**Merton Council**  
**Development and Planning**  
**Applications Committee**

### Modifications Sheet.

## ITEM 5 (BURLINGTON GATE 42 ROTHESAY AVENUE WIMBLEDON CHASE SW20 8JU)

DRAWING  
Proposed Site Plan

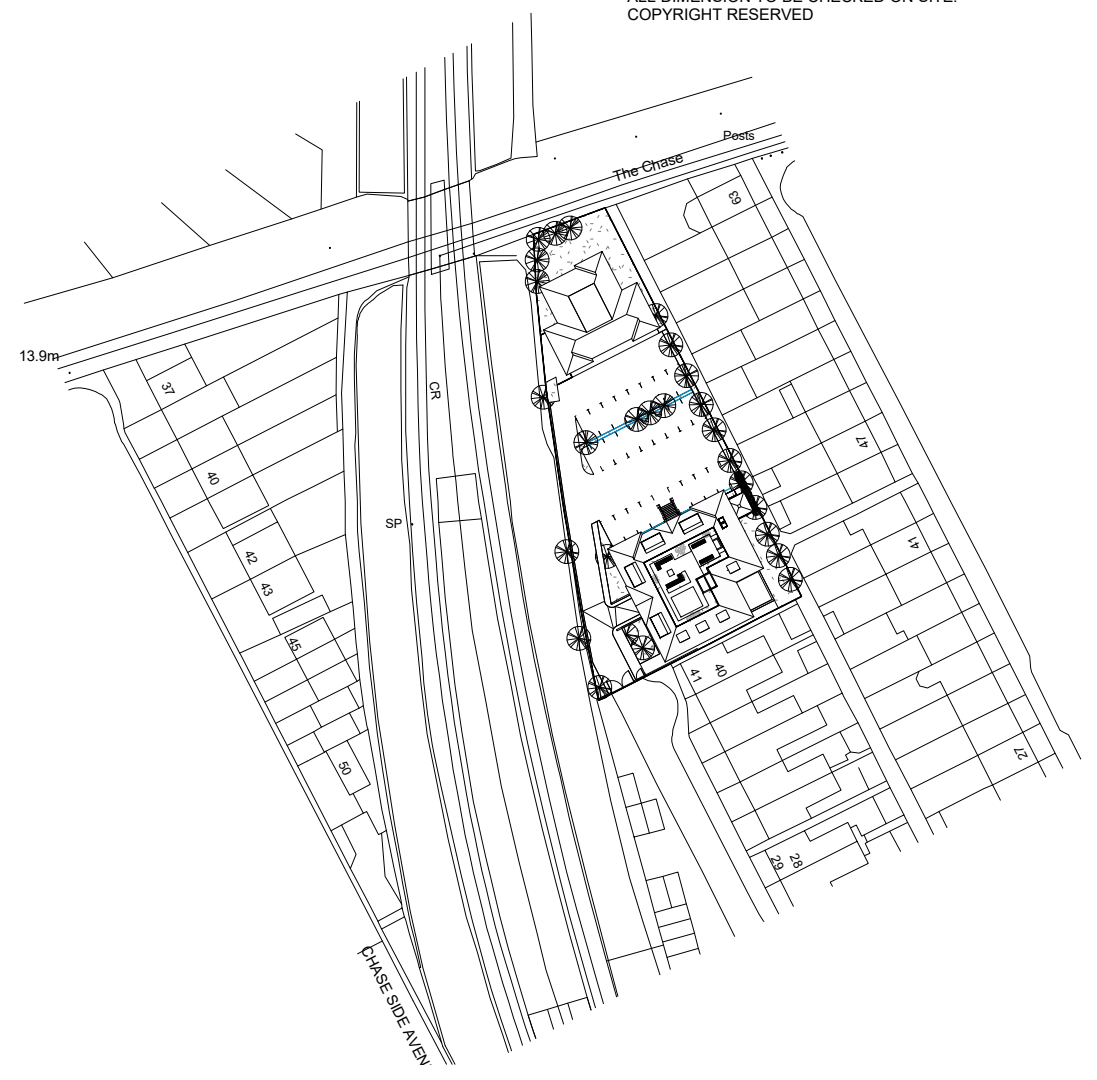
- Proposed Site Plan (showing proposed bin storage and rooftop landscaping) 22.11.2023
- Proposed Ground Floor (showing covered summerhouse) 22.11.2023
- Proposed 4<sup>th</sup> Floor Plan (showing internal bin storage arrangements) 22.11.2023
- Proposed Roof (showing landscaping) 22.11.2023
- Proposed East & North Elevation (showing summerhouse) 22.11.2023
- Proposed Roof Terrace Landscaping 22.11.2023
- Proposed Section AA (showing previous refused scheme) 22.11.2023

- A covered summerhouse as opposed to a pergola, at ground level.
- The arrangement of proposed landscaping to the rooftop terrace, including planting, seating, surfacing (a combination of light coloured paving slabs, composite decking), BBQ area, timber pergola and wall and floor lighting.
- Internal arrangements to demonstrate that internal bin storage can be adequately accommodated.
- Details of the proposed bin storage area, which would involve a slight enlargement of the enclosed area to provide an additional 1100 litre Euro bin and a new bin for food waste. (There is capacity for 5 Euro bins currently).

- *The proposed landscaping arrangements can be secured by way of condition. If alterations are required to the layout, this can be resolved through a pre-commencement condition (for example, the acceptability of the proposed BBQ area in terms of fire safety would need to be resolved before this arrangement could be agreed and also the acceptability of the lighting arrangements proposed). However, the plans show indicative images of what could be required and secured by way of condition should the application be approved.*

- *The amended floor plans show where refuse and recycling can be stored internally and this raises no concerns.*
- *The level of bin storage for the resultant 37 units (6 Euro bins, along with a further bin for food waste storage) would be in line with the Council's requirements for bin storage and no concerns are raised. The marginal forward projection of the enclosed bin store is not considered to result in material harm to either visual or residential amenity.*

DRAWING  
Proposed GF Plan

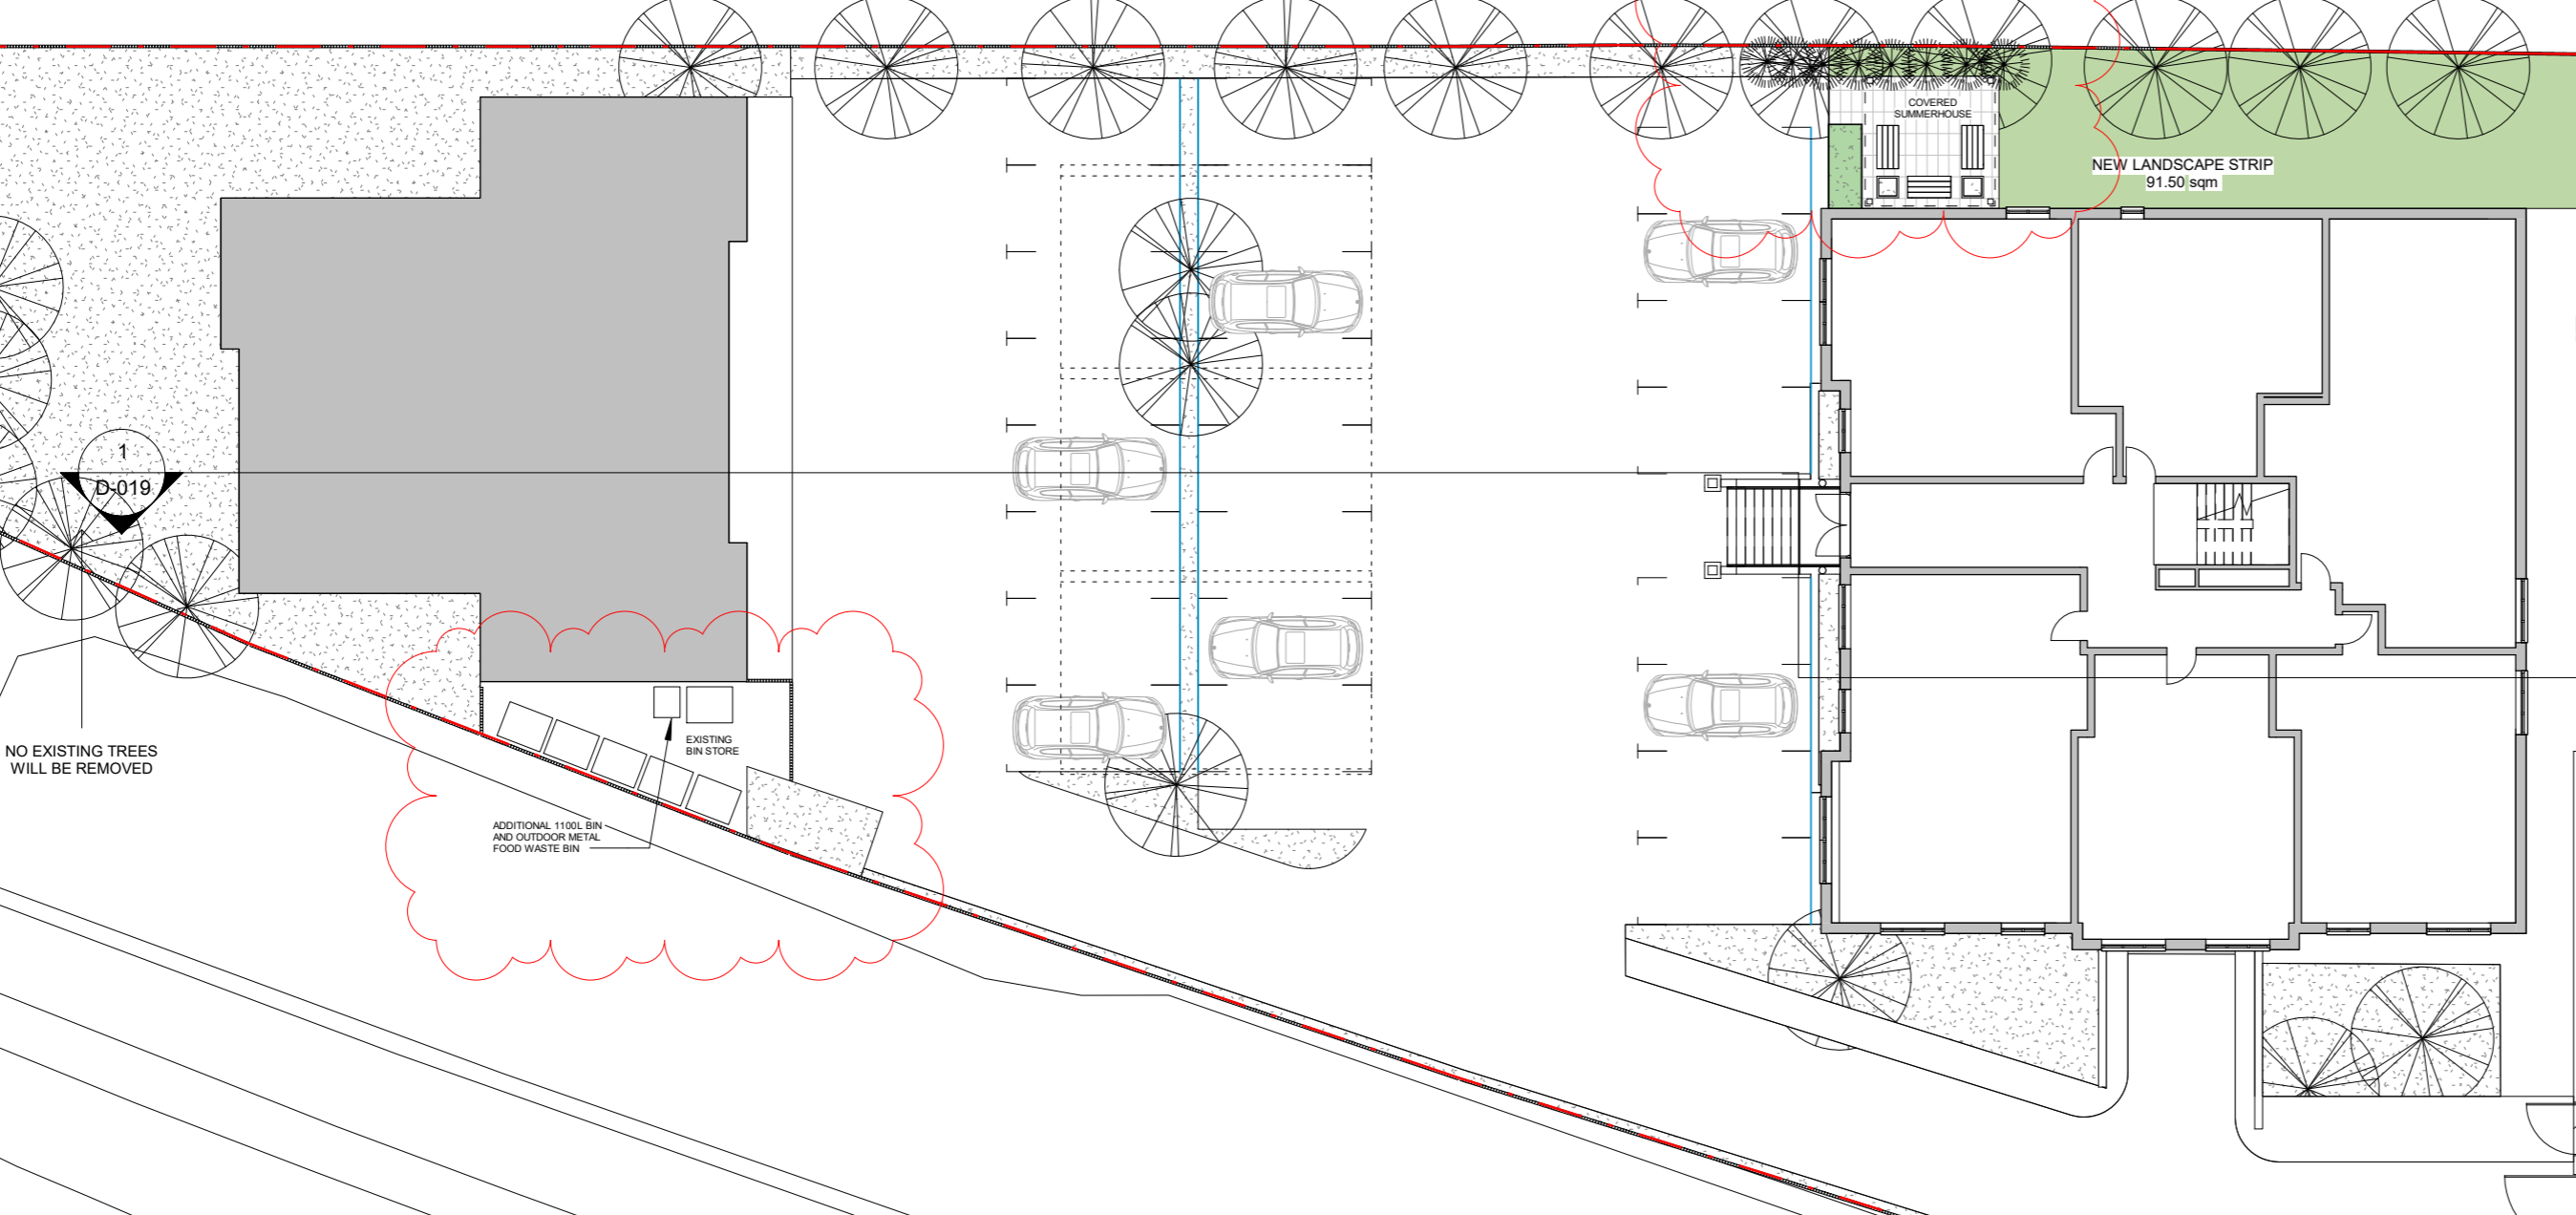
ADDITIONAL 1100L BIN AND OUTDOOR METAL FOOD WASTE BIN

DRAWING  
**Proposed Roof Plan**

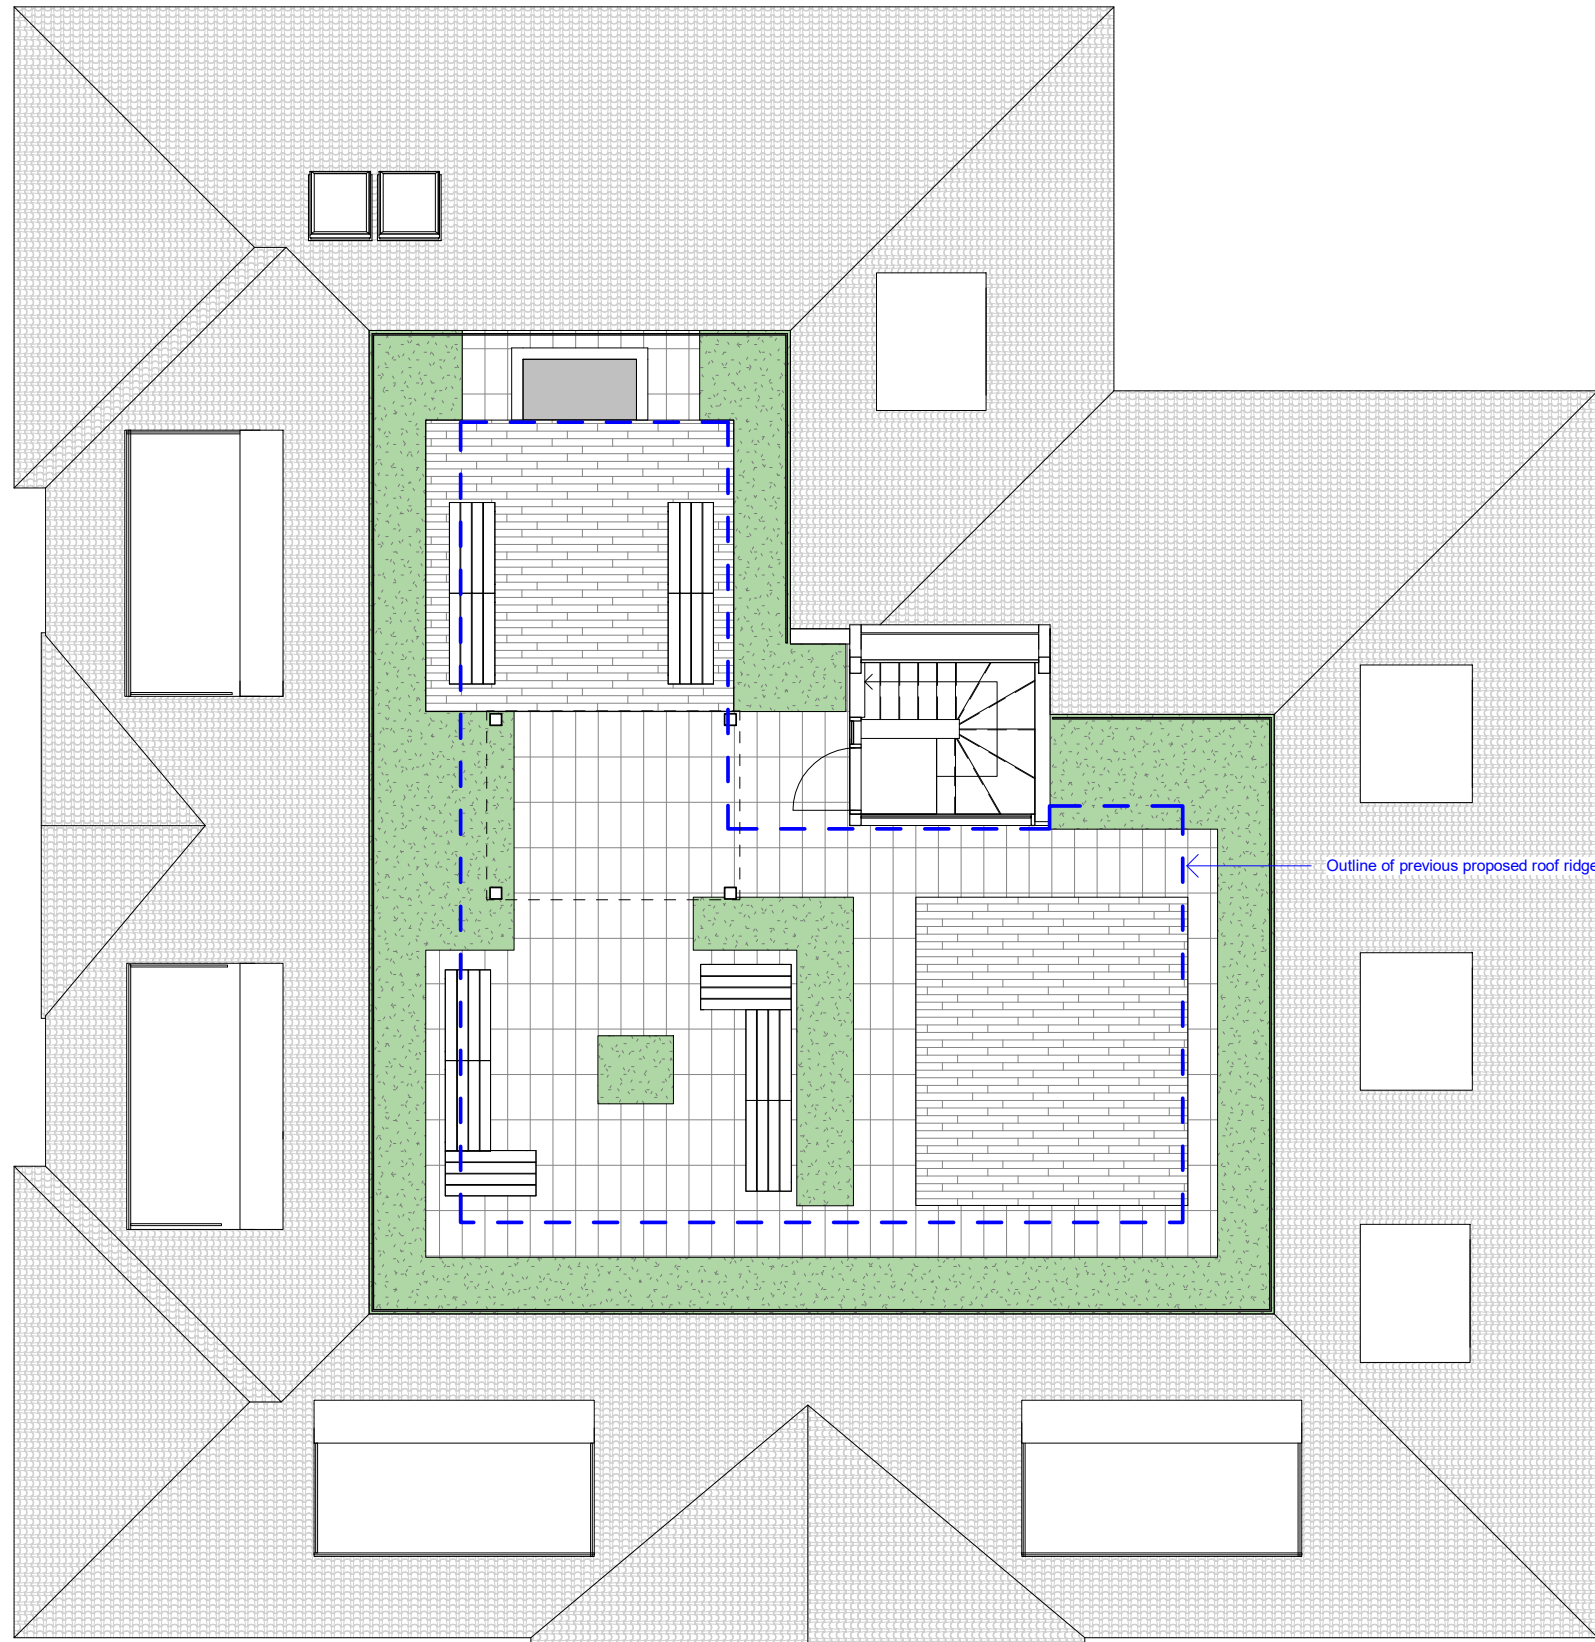
← Outline of previous proposed roof ridge line

DRAWING  
**Proposed Section AA**

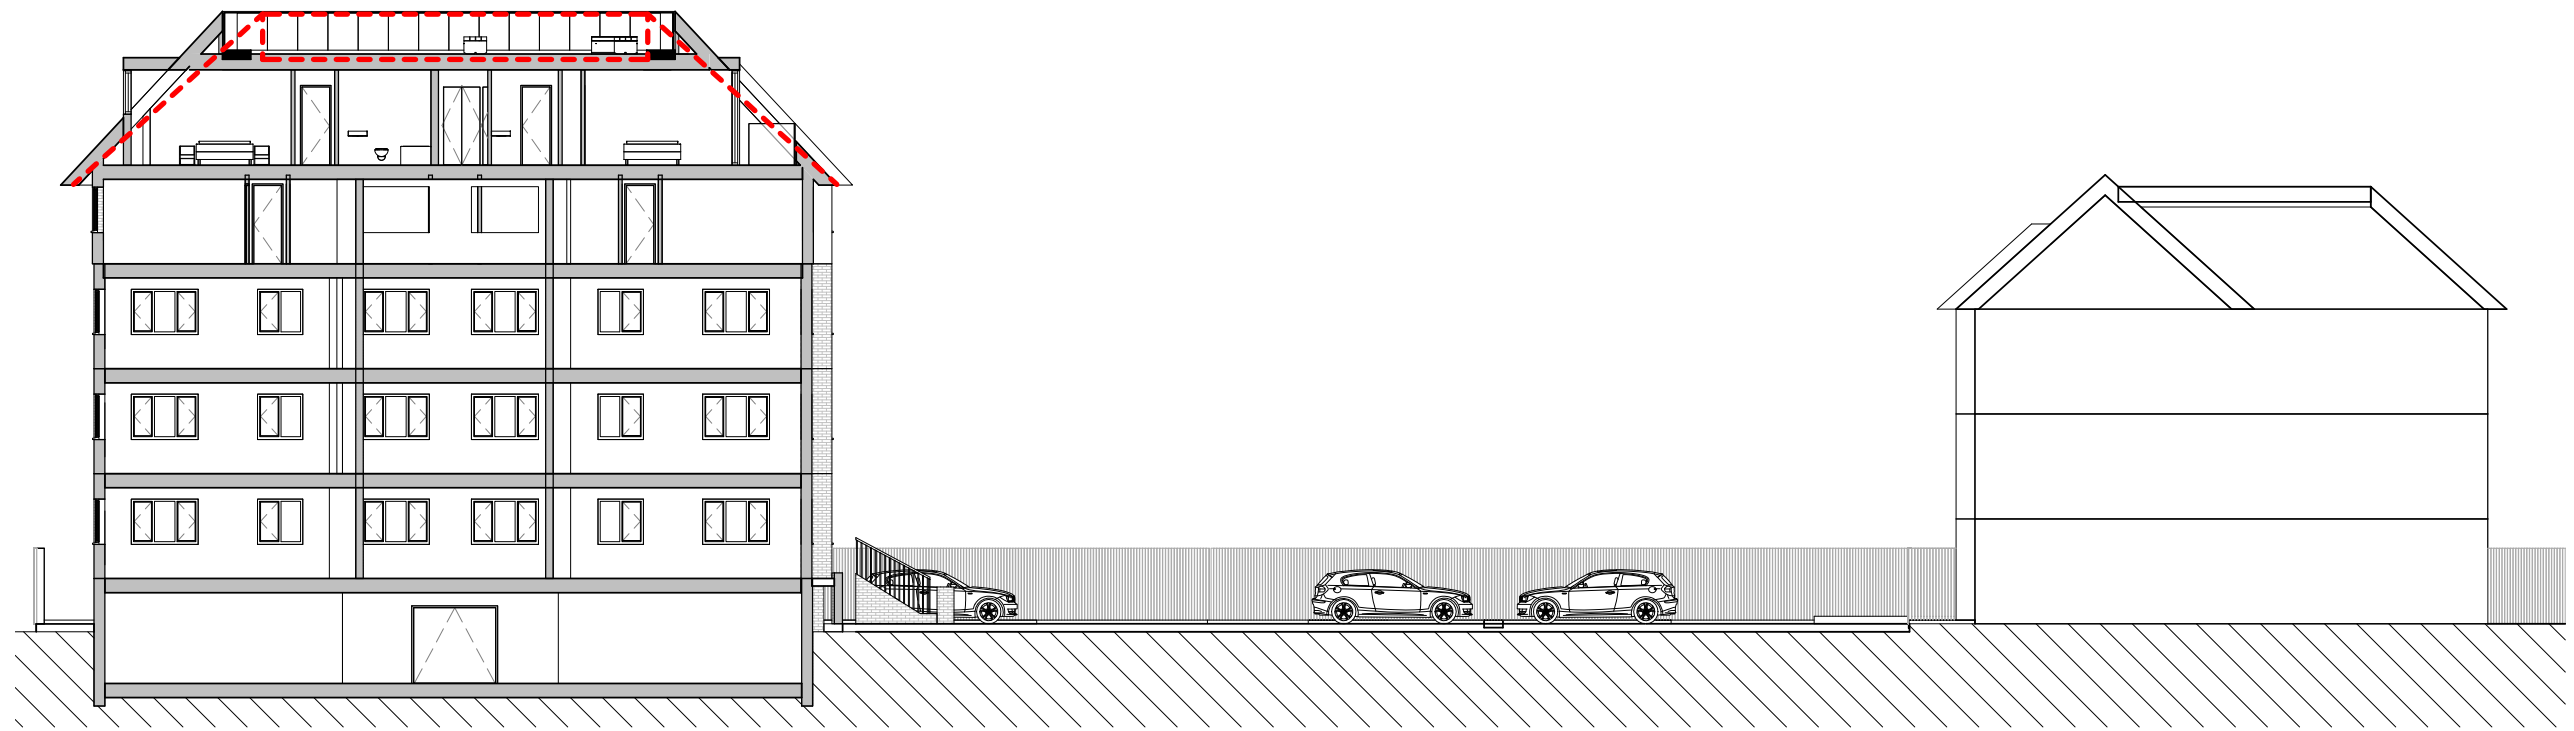
----- Planning Application Ref: 21/P3292 highlighted in dotted red
